Errata for
Introduction to Structural
Dynamics and Aeroelasticity, Second Edition

Dewey H. Hodges and G. Alvin Pierce
Errors in Fifth Printing (to be corrected in Sixth Printing)

December 8, 2016

Figure 4.4: Plot of $1/\theta$ versus $1/q$

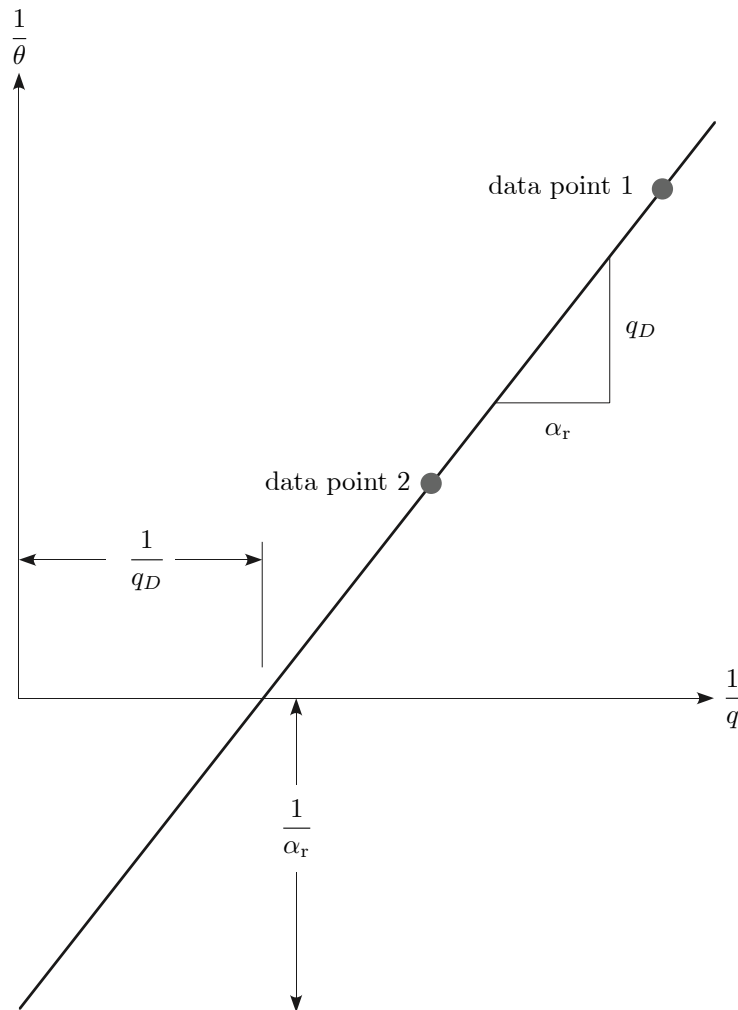
132 The slope indicated for the line in Fig. 4.4 should be q_D/α_r as indicated herein.
